Anthropomorphic Test Dummy; Occupant Crash Protection

ACTION: Notice of proposed rulemaking.

SUMMARY: This document proposes modifications to the Hybrid III test dummy, which is specified by the agency for use in compliance testing under Standard No. 208, Occupant crash protection. The agency is proposing minor modifications to the femurs and ankles to improve biofidelity, and is considering

FIGURE 20

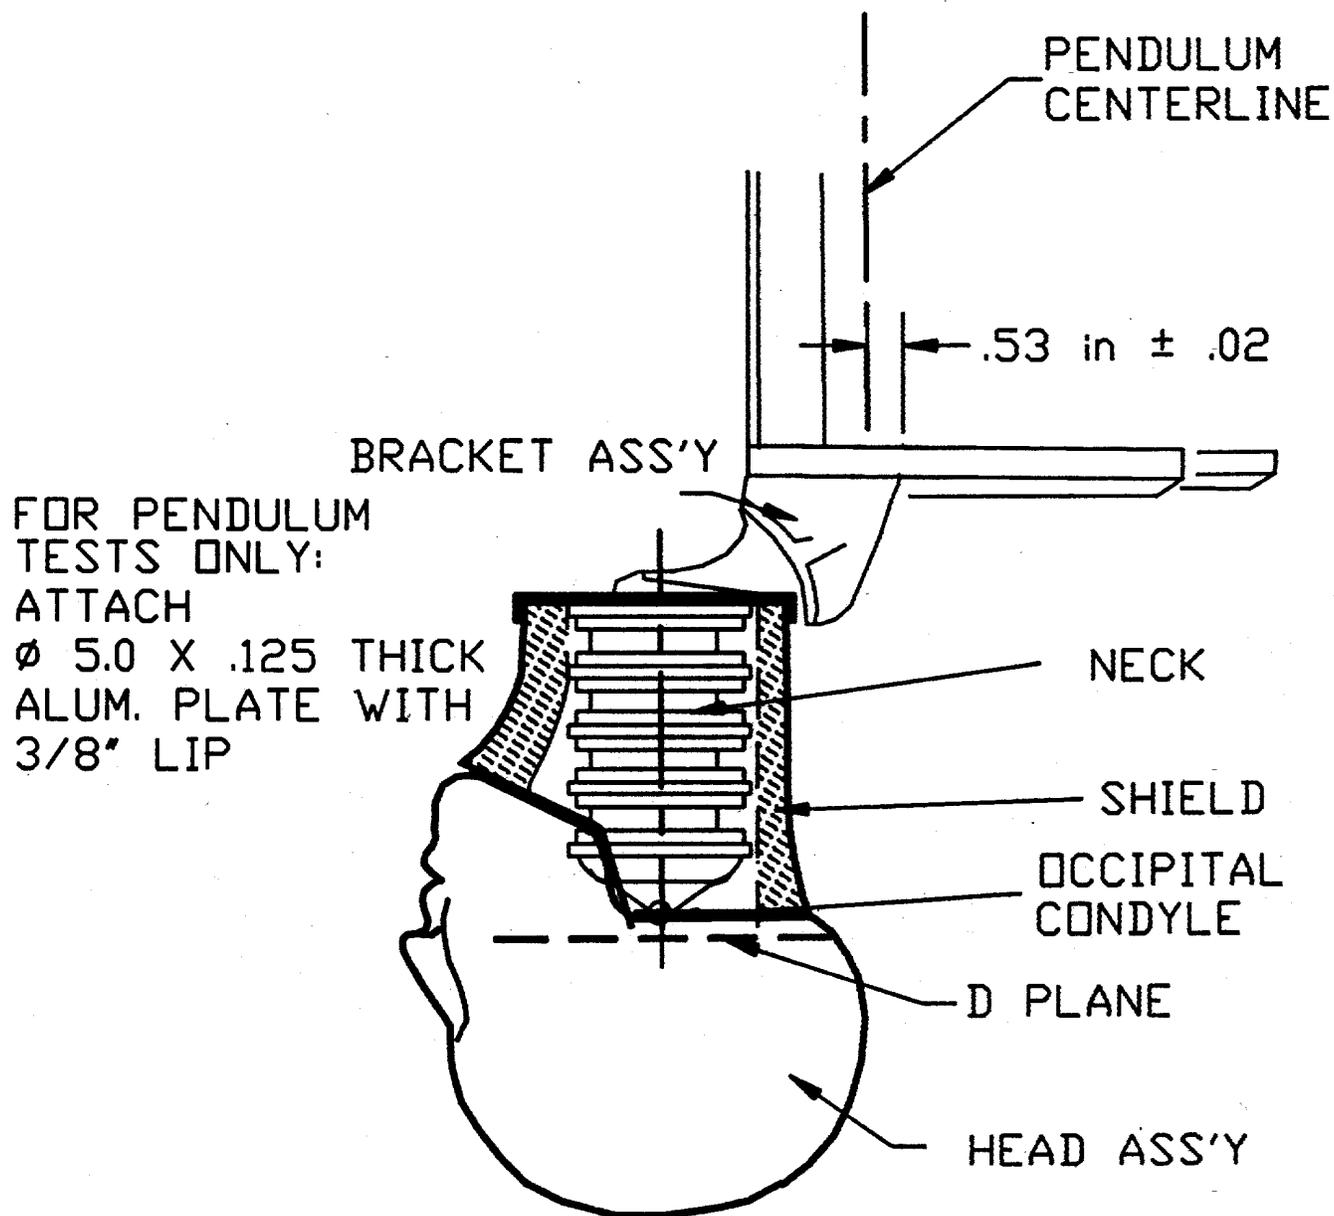
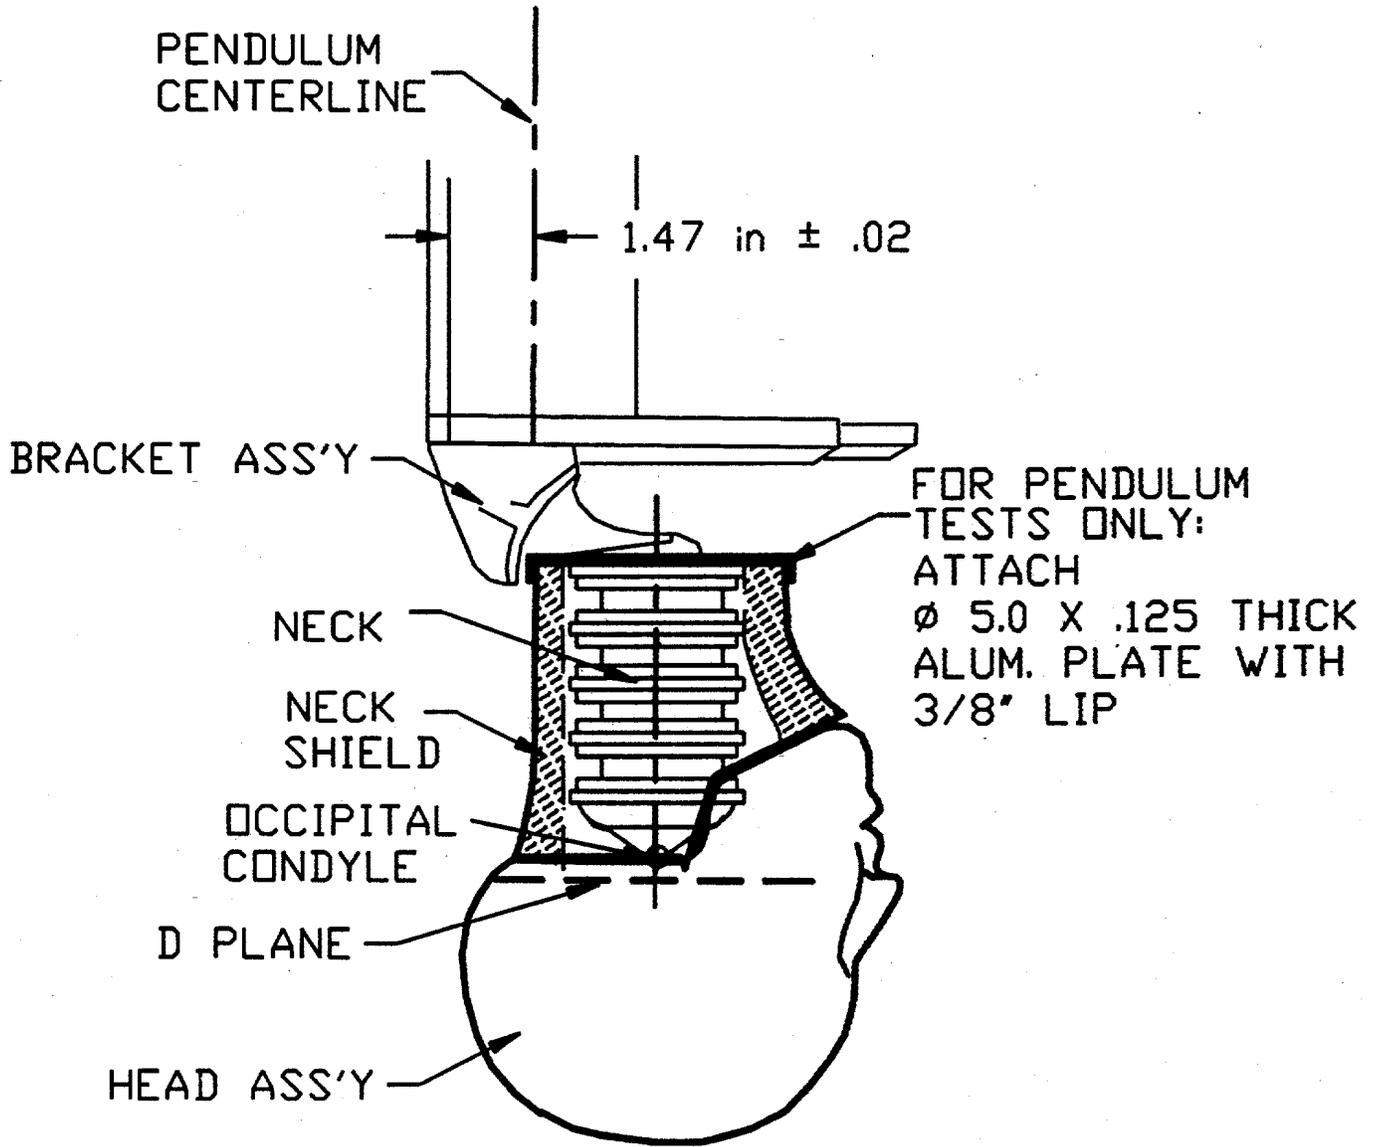
3. Section 572.33 would be amended by moving Figures 20, 21 and 22 to the end of the section and adding a heading preceding Figure 20, revising paragraph (b) introductory text, and revising Figures 20 and 21, to read as follows:

(b) When the neck and head assembly (consisting of the parts 78051-61, revision T; -84; -90, revision A; -96; -98; -303, revision E; -305; -306; -307, revision X) which has a neck transducer (drawing 83-5001-008) installed in conformance with § 572.36(d) and a neck shield as shown in Figures 20 and 21, is tested in accordance with paragraph (c) of this section, it shall have the following characteristics:

Fig. 25

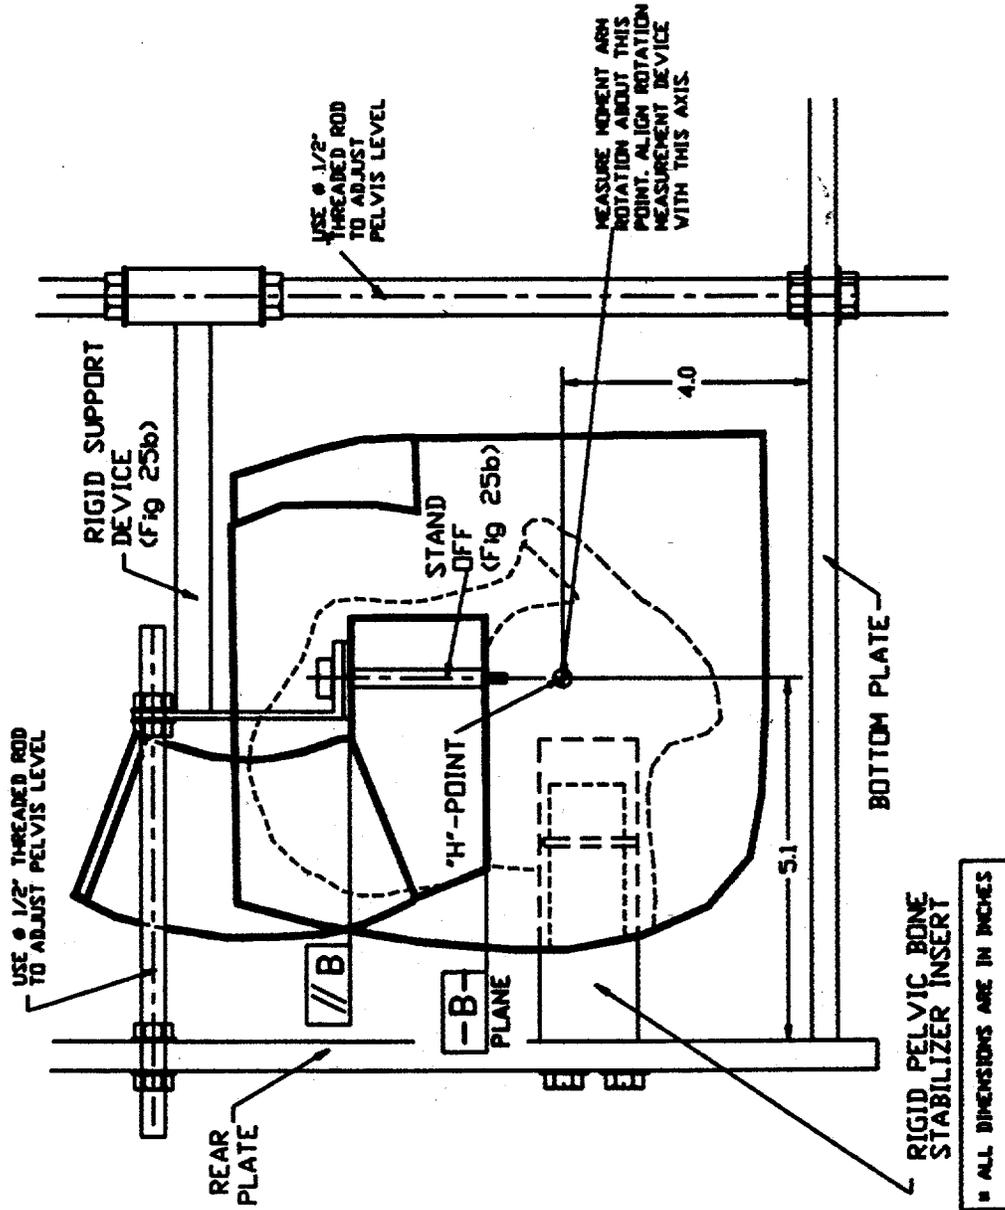
(ii) Seat the dummy on a rigid seat fixture (Figure 25) and firmly secure it to the seat back by bolting the stabilizer insert and the rigid support device (Figure 25b) to the seat back of the test fixture (Figures 26 and 27) while maintaining the pelvis (78051-58) "B" plane horizontal.

Fig 25a

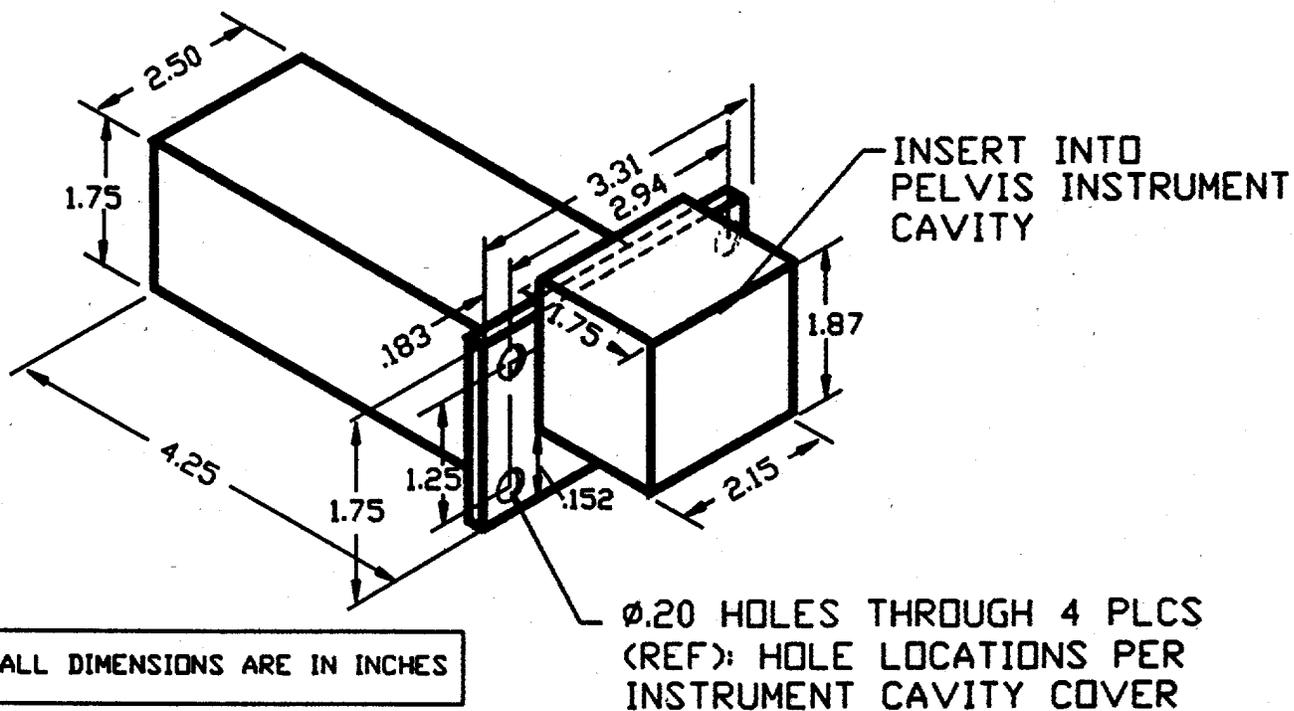
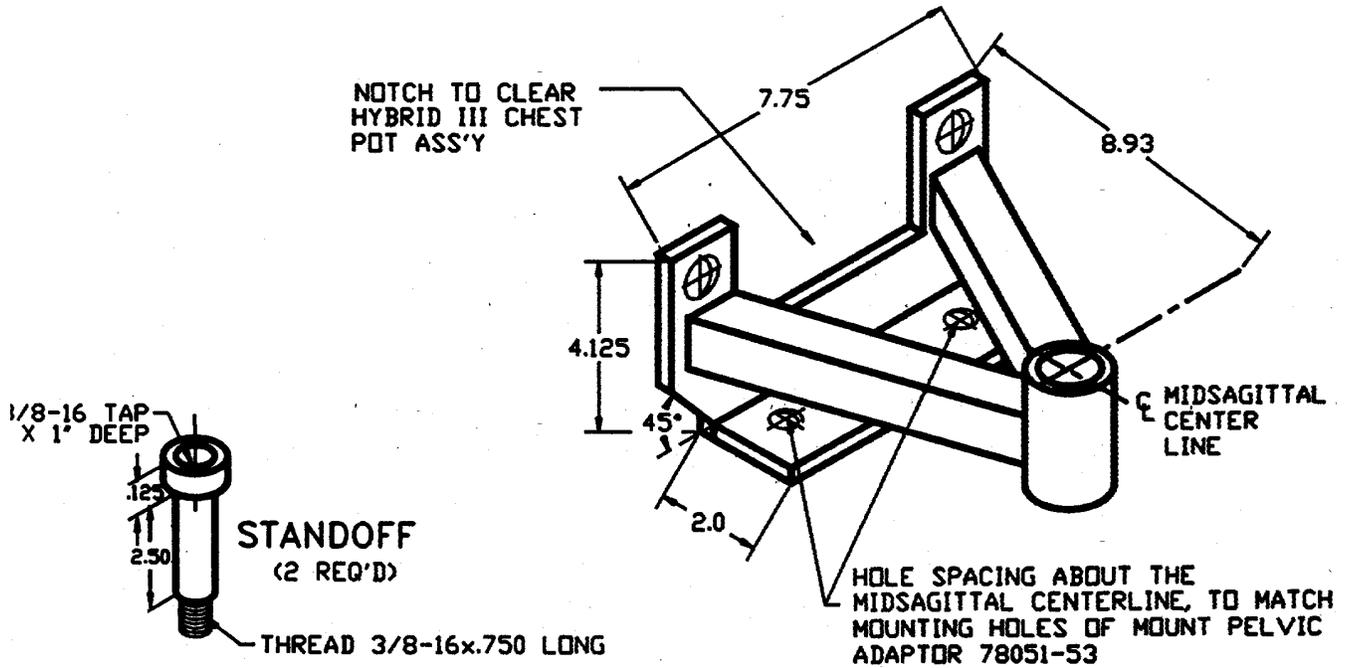
(rev. S) except that (1) leg assemblies (86-5001-001 and 002) are separated from the dummy by removing the 3/8-16 Socket Head Cap Screw (SHCS) (78051-99) but retaining the structural assembly of the upper legs (78051-43 and -44), (2) the abdominal insert (78051-52) is removed and (3) the instrument cover plate (78051-13) in the pelvic bone is replaced by a rigid pelvic bone stabilizer insert (Figure 25a) and firmly secured.
